TOWN OF PORTOLA VALLEY
REGULAR PLANNING COMMISSION MEETING
765 Portola Road, Portola Valley, CA 94028
Wednesday, October 16, 2013 – 7:30 p.m.
Council Chambers (Historic Schoolhouse)

TO: Planning Commission
FROM: Tom Vlastic, Town Planner
DATE: October 11, 2013
RE: Agenda for October 16, 2013 Planning Commission Meeting

Site Development Permit X9H-656, 5 Naranja Way, Maffia

Sheet C01, Grading & Drainage Plan, Civil Plans, Freyer & Laureta, Inc., Civil Engineers, 10/2/13

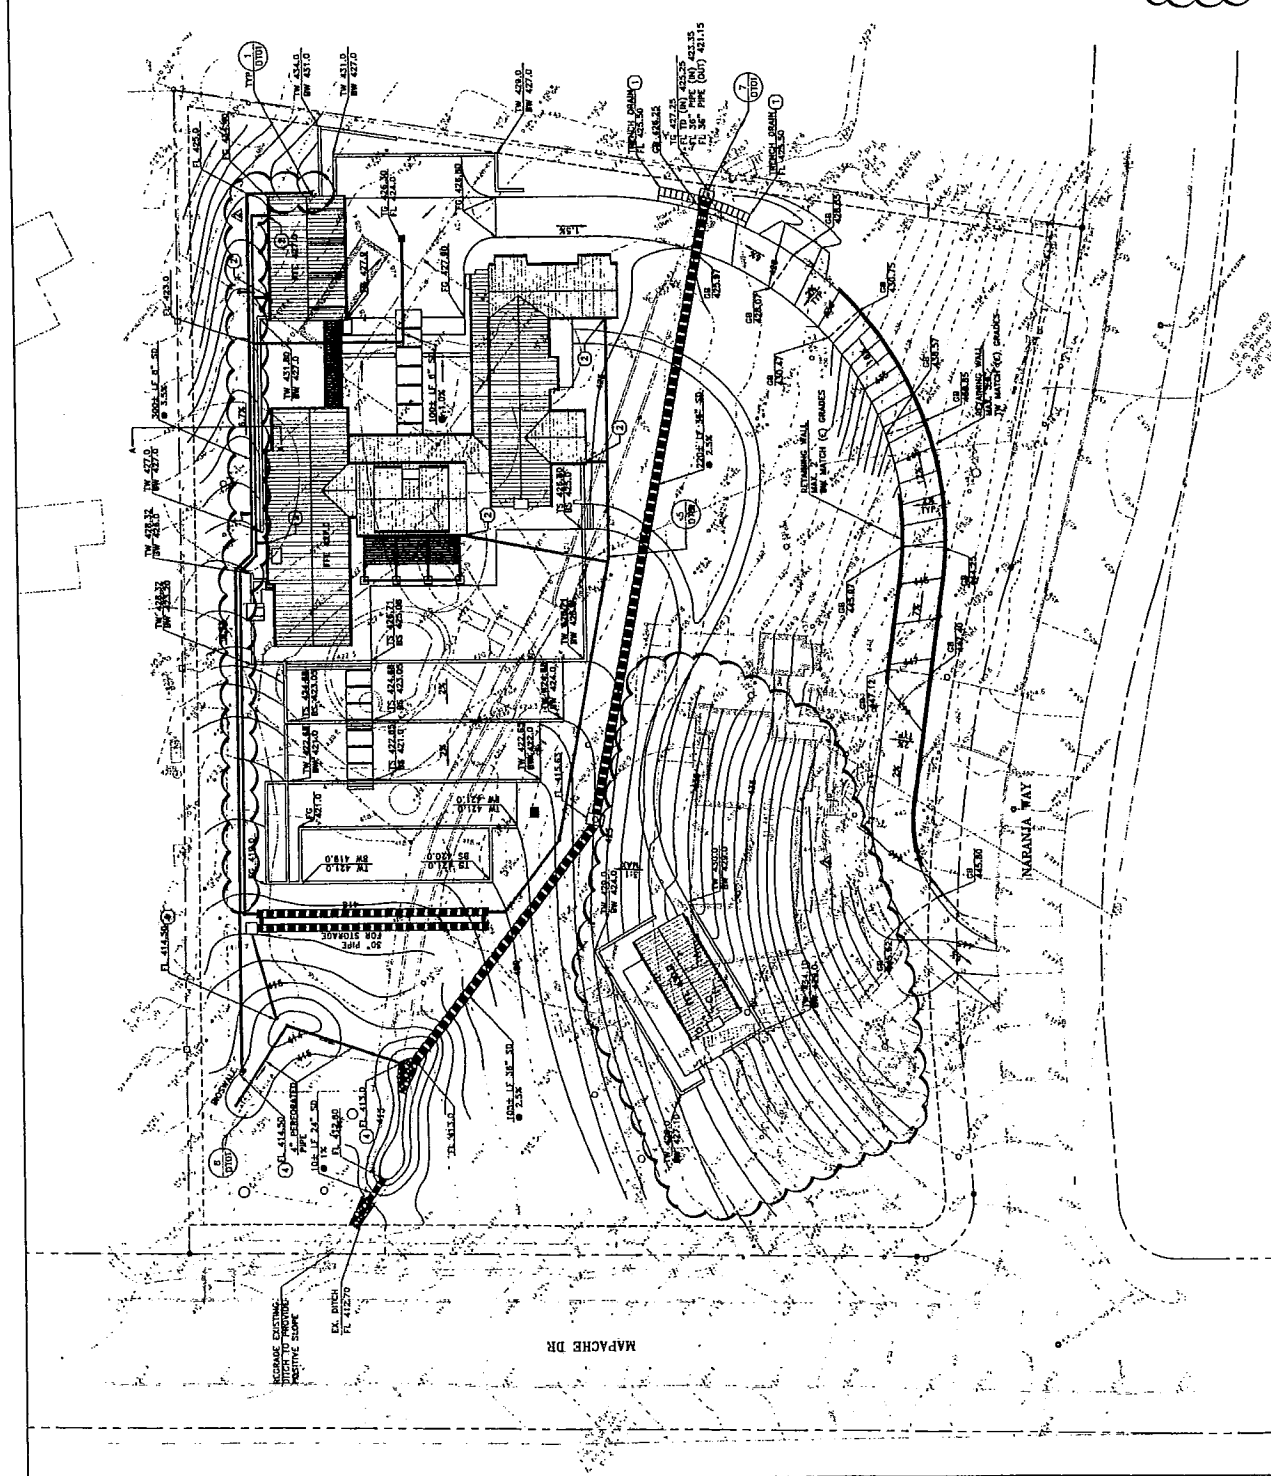
Also attached is grading plan Sheet C01, dated 9/12/13, as considered at the ASCC's 9/23 site and evening project approval meetings. This sheet shows the correct location for the detached office and the grading related to it. The revised plan dated 10/2/13 shows the final grading plan with the changes that reflect ASCC approval conditions, but the office site was modified to meet the WASC setback standards as understood at the end of the 9/23 review. After the plan was revised, it was found that the office siting as shown on the 9/12/13 plan did actually meet the final WASC setback requirements. Thus, the request is to approve the 10/2 grading plan, but with the understanding the office will be located as shown on the 9/12 plan and the grading for the office will also be as shown on the 9/12 plan.

Sheet C01 – Grading and Drainage Plan:

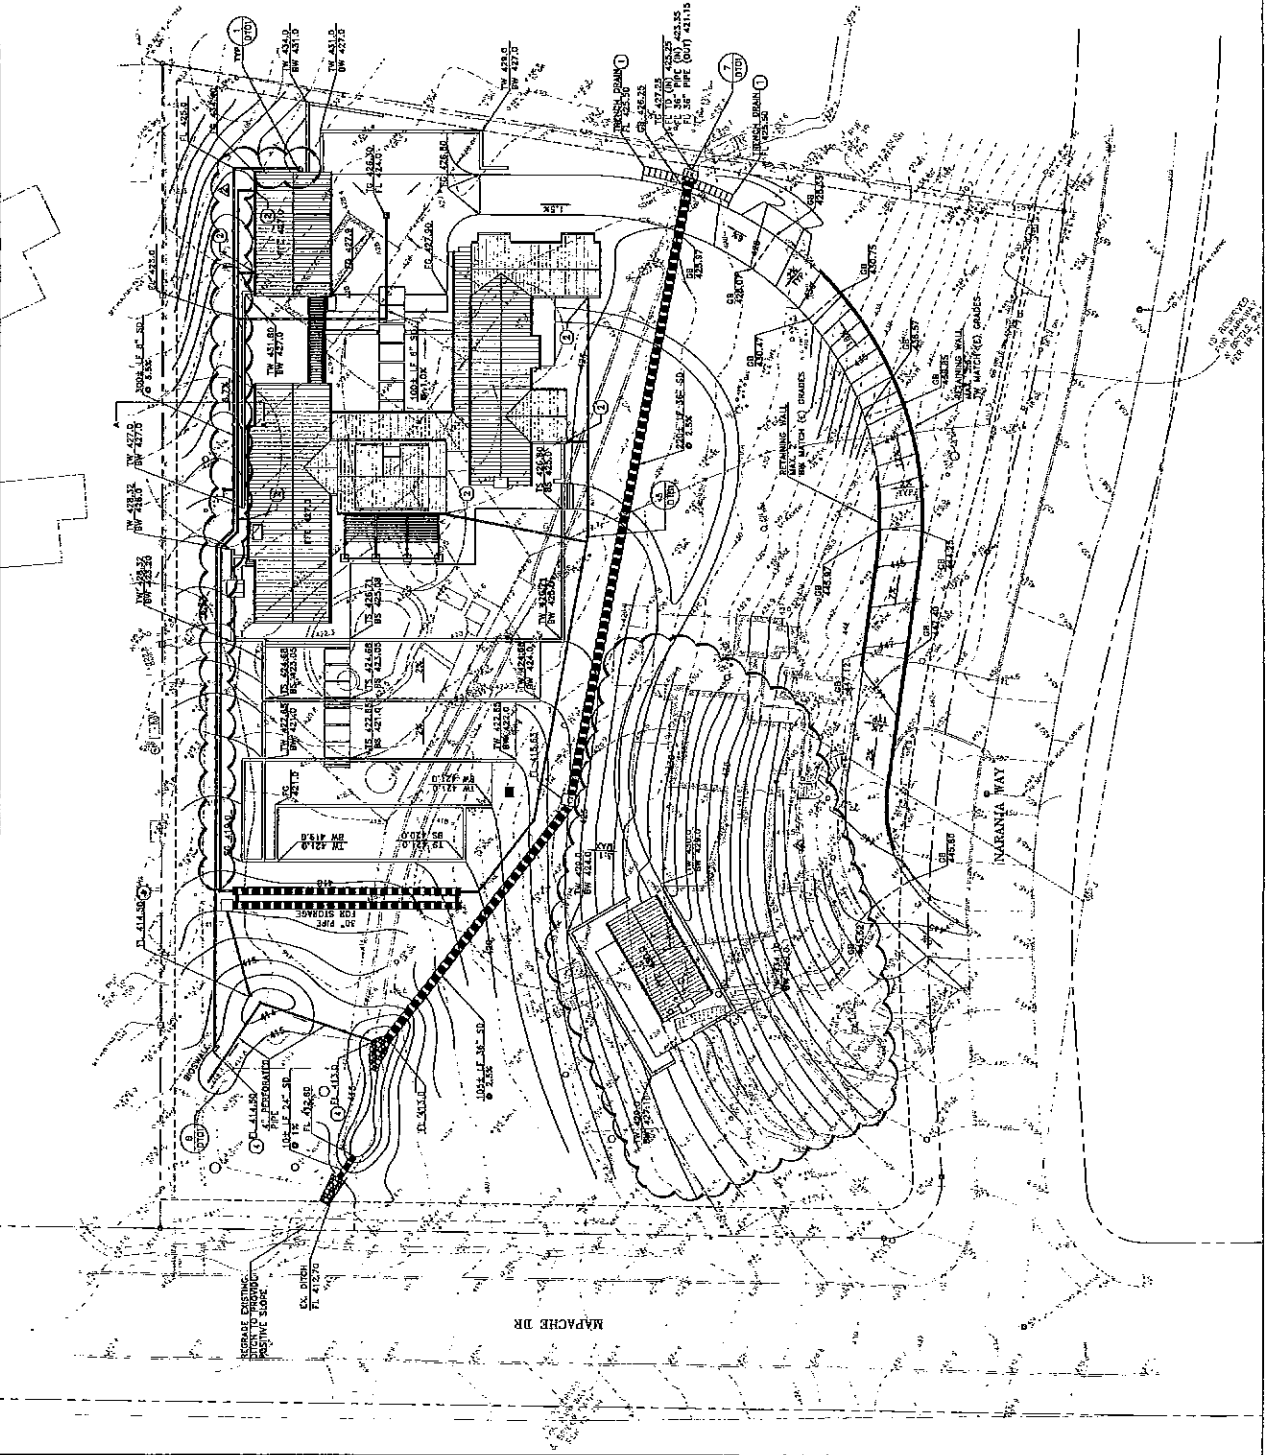
1. Callout Detail 6 on sheet DT01 in the driveway area above the 36” SD pipe.
2. Add the junction box symbol in the legend and show a detail on sheet DT01.

EXTERIOR LIGHTING PLAN
L5.0

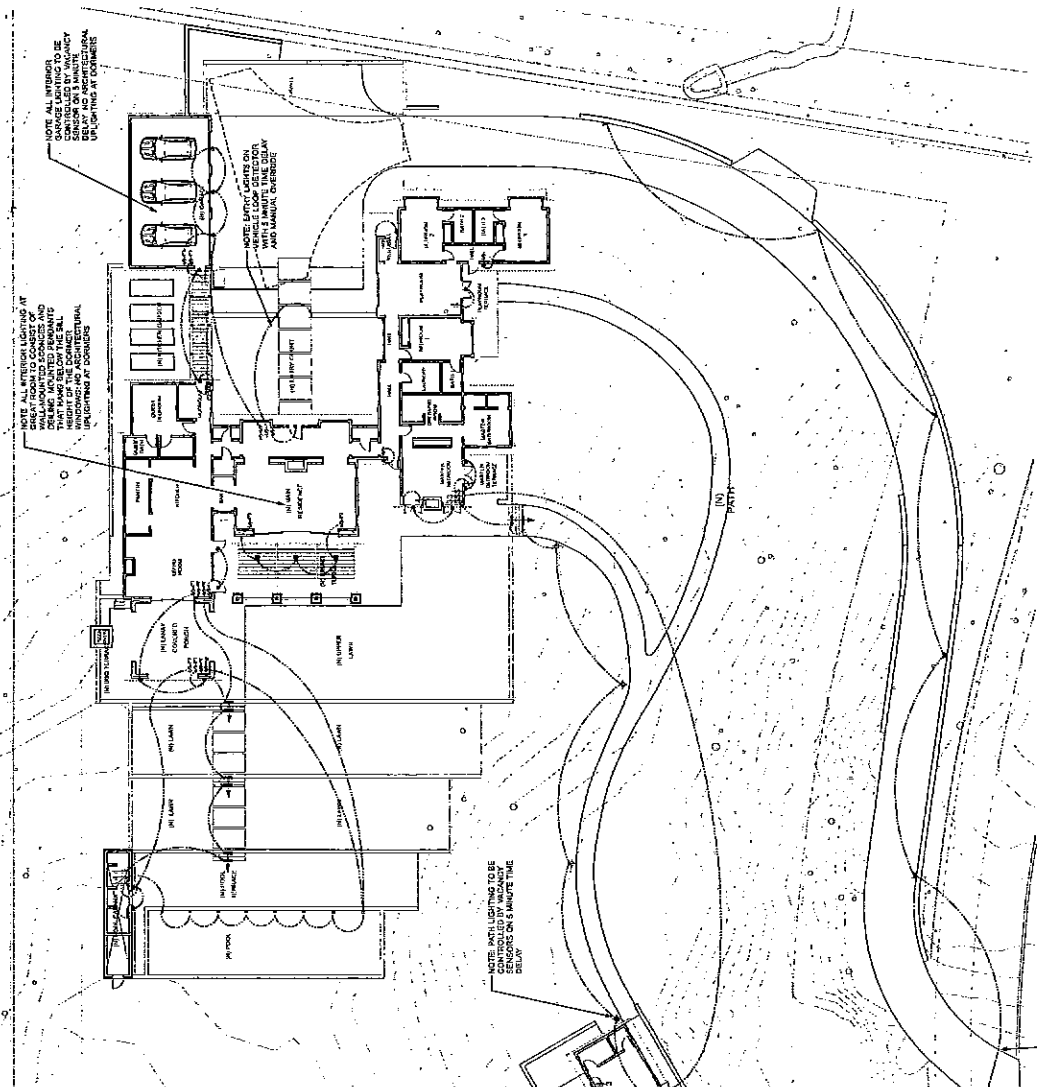
The plans still propose the use of the Cooper Lighting fixture 660-WP series with open top, sides and bottom, i.e., "architectural sconce" identified on Sheet L5.0. One additional such light is proposed, but this is a result of the design change to the cabana and elimination of the three proposed trellis lights with the original design. We don't take issue with the placement of the fixtures, but still have concerns over the open design and potential for light spill. We recommend that instead of the Cooper fixture, the Hunza-wall fixture be used or a different fixture be selected that only directs light down. Otherwise, we believe the revised lighting plans are responsive to the preliminary review comments.

5. **Clerestory/interior lighting.** The notes on plan Sheet L5.0 are consistent with the plans approved by the ASCC relative to clerestory design and interior lighting. The neighbors have indicated their desire that, essentially, the clerestory elements be eliminated if they can't be hidden from view from their property. The garage clerestory faces fully away from 170 Mapache Drive.

SITE PLAN
A1.01 1/8" = 1'-0"

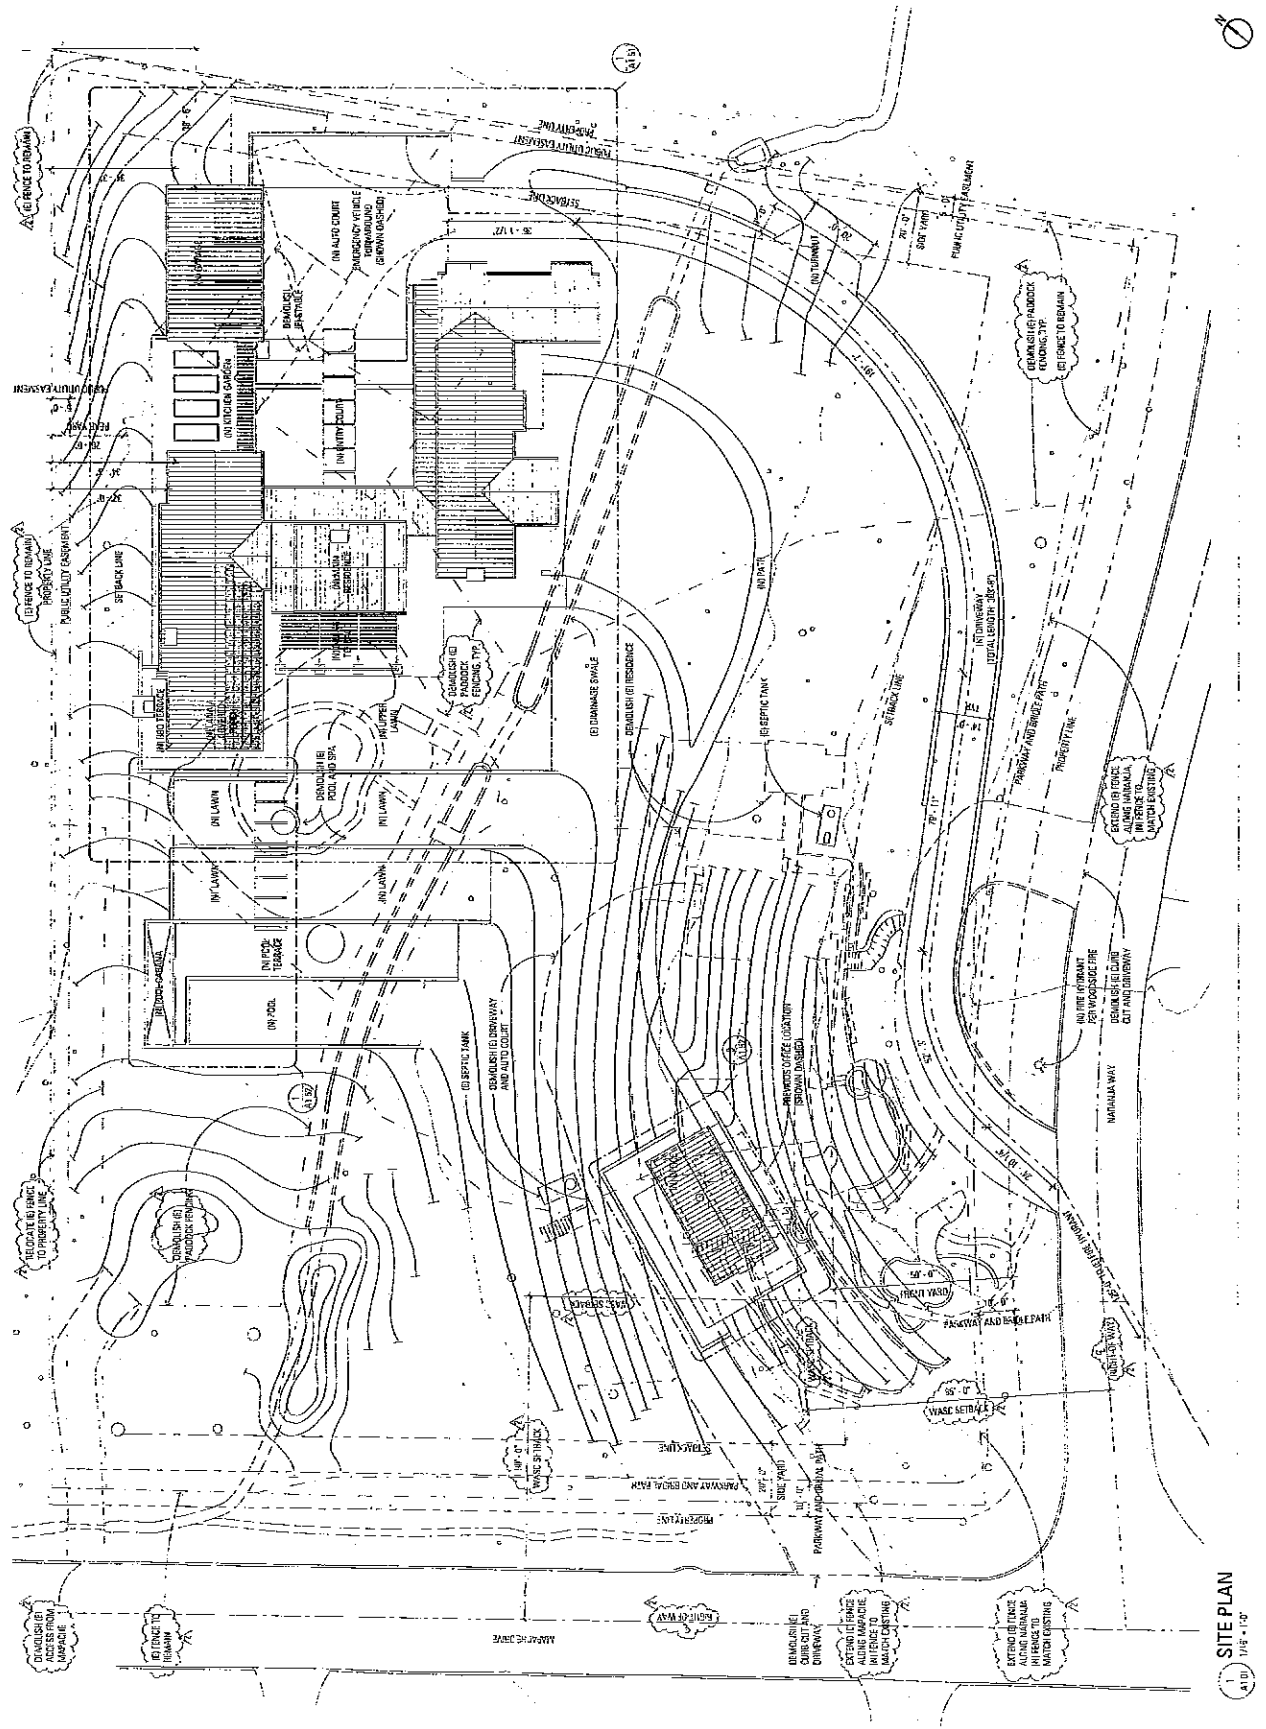
As noted in the submittal materials, the siting of the office as considered at the site meetings does not need any adjustment for conformity to Westridge Architectural Supervising Committee (WAS) setback standards. The grading plan and landscape plan sheets were modified when it was not clear as to the setback requirements. However, when the WASC did clarify the setbacks, it was found that no adjustment would be necessary. Thus, all final site plans will be consistent with the office siting on enclosed plan sheet A1.01.

6. **Fencing.** As noted on plan sheet A1/01 and clarified with the 10/8 email, the plan is to only use new fencing to fill in openings in the existing horse fence property boundary fencing and to relocate the existing north side fencing. All fencing, whether relocated or new in fill, will be no higher than four feet and match the existing horse fence design. Thus, the fencing plan does conform to town fencing standards that specifically included for "horse" style fencing to be in setback areas.

- 4) The existing fencing along the west end of the north property line will be relocated to the north property line as indicated on the revised site plan A1.01. The existing fencing along Mapache and Naranja will also be extended to enclose the entire property as indicated on the revised site plan A1.01. All new fencing will match the style and character of the existing fence which consists of vertical wood posts spaced roughly 8 feet on center connected by 3 horizontal wood rails with wire deer fencing in between.

- 1) Curb cuts along Mapache Drive have been will be eliminated upon completion of the project as indicated on the revised site plan A1.01 and no new access from Mapache Drive is being proposed.

- 3) The office structure in the previously proposed location complies with the WASC setbacks as indicated on the revised site plan A1.01 dated 10/2/13. As clarified by Rusty Day of the WASC by email on 10/2/13, the required WASC setbacks are 50 feet from any public right-of-way which includes both the road right-of-way as well as the 10 foot wide parkway and bridal path easement along Mapache Drive and Naranja Way. The setback requirements therefore consist of 90 feet from the centerline of the Mapache right-of-way and 85 feet from the Naranja right-of-way. As indicated on A1.01, the office structure is located well outside of these required setbacks.

Note: Due to a last minute clarification regarding the specific WASC setback requirements that was received after the drawings had been revised, the office was prematurely shifted to the northeast and is shown incorrectly in the landscape and civil drawings. The architectural site plan A1.01 dated 10/2/13 shows the intended location which is compliant with the confirmed setback requirements. The planting plan, lighting plan, grading plan and earthwork calculations were not significantly impacted by this change. Please refer to A1.01 for the correct office location.

**Proposed
Site Plan**

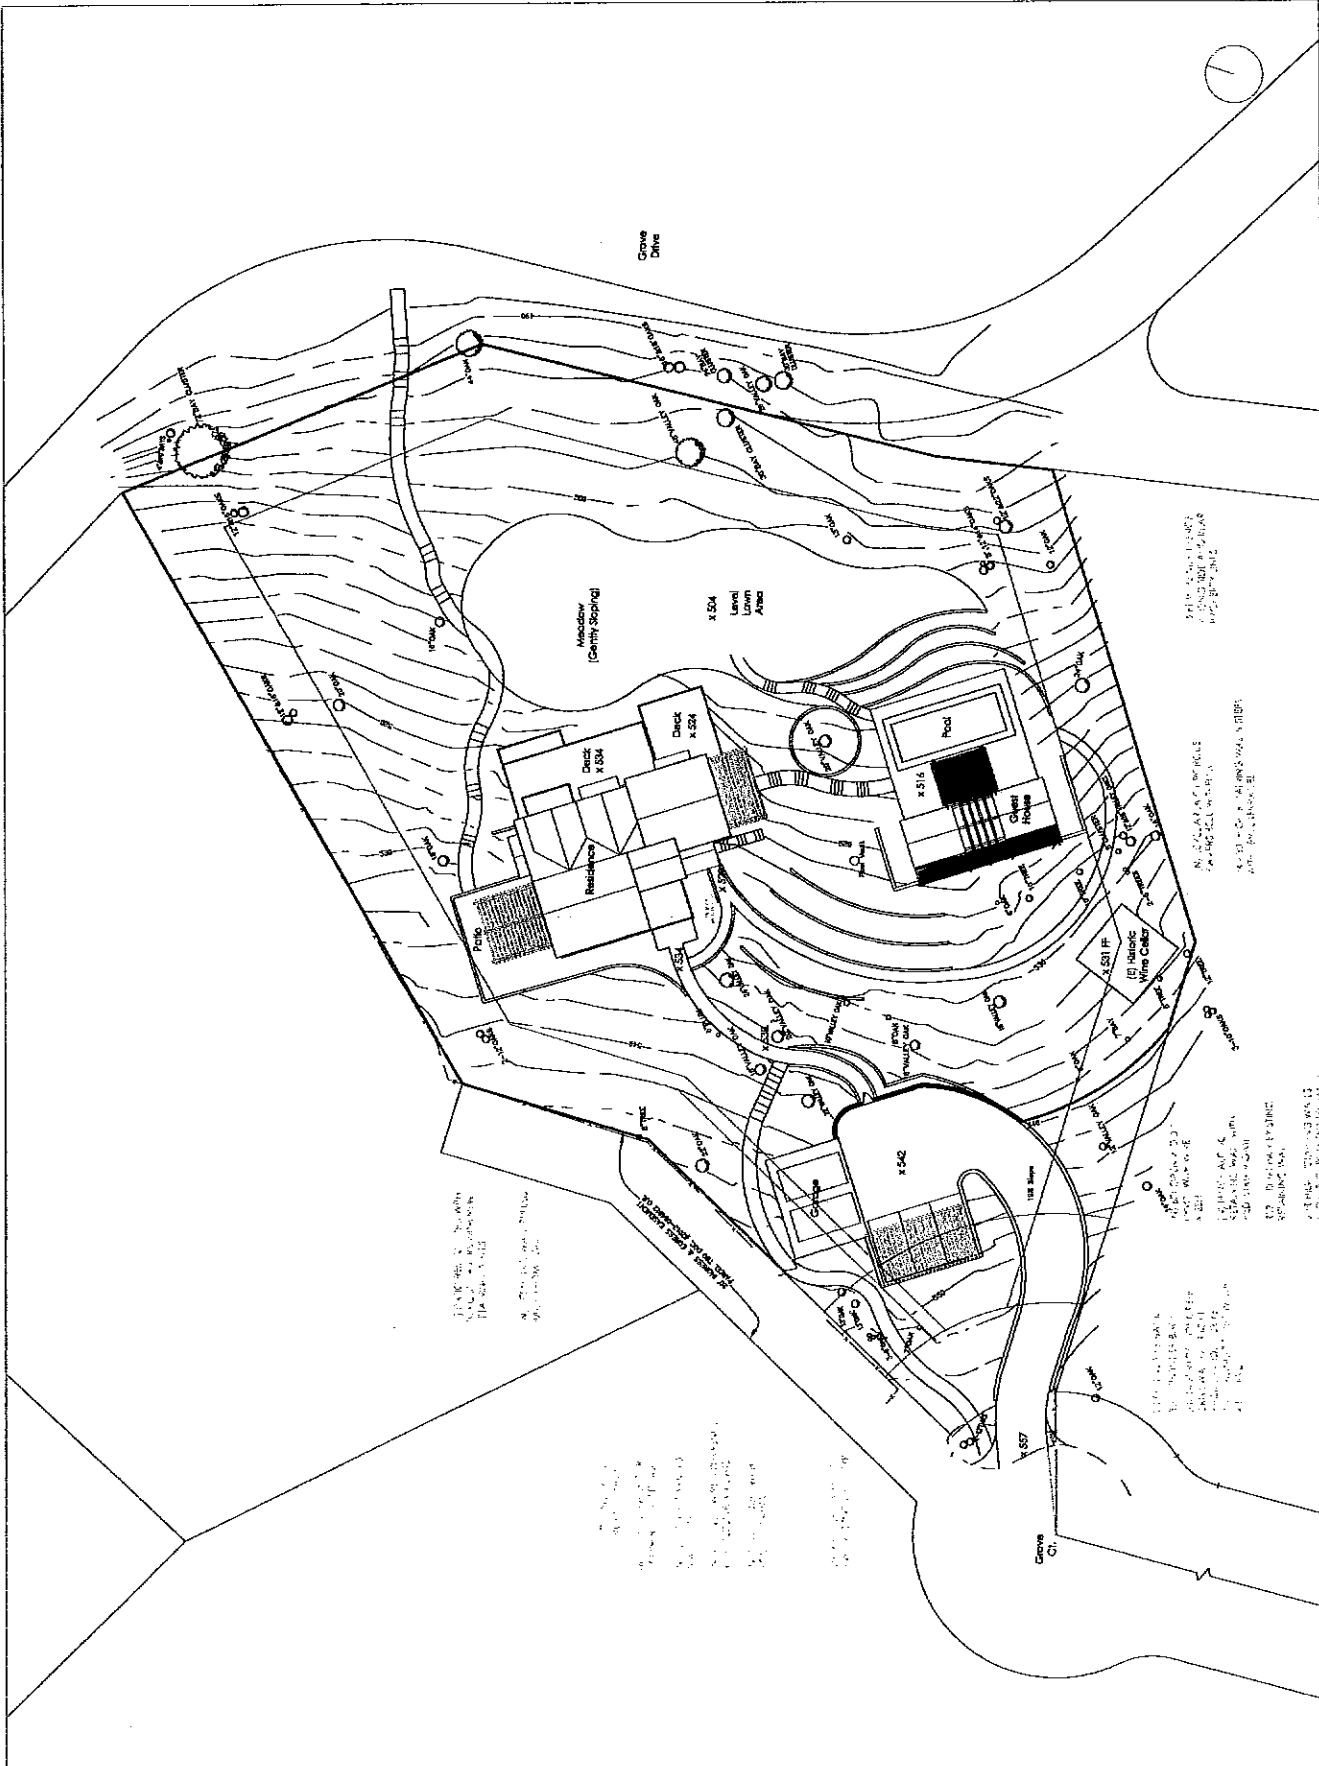
- a. Permit the proposed garage to encroach 15 feet into the required 20 foot northwest side yard. (Shown on Sheet A2.2.) This includes elimination of the existing driveway access from the easement, but does preserve space for a pathway that would connect to the existing stone pathway from the easement to the subject site and historic house. In any case, the majority of this existing, historic pathway material should be preserved or reused in the planned site work.

- b. Permit the guest parking area to have a 12-foot high trellis for screening that extends a maximum of 9 feet into the required 50-foot front yard setback. (Shown on Sheet A2.2.) Under averaging provisions a structure could extend 10 feet into the setback, but this structure does not meet the averaging provisions. Further, an ornamental garden structure, to a maximum of 12 feet can extend into a setback and a simple trellis without parking underneath could be considered a ornamental structure. These comparisons are offered mainly to show that the applicants, while dealing with site conditions and problems, have attempted to design to the spirit of the ordinance if not the specific standards. It is noted that the scope of parking is needed for zoning ordinance conformity to current residential standards.
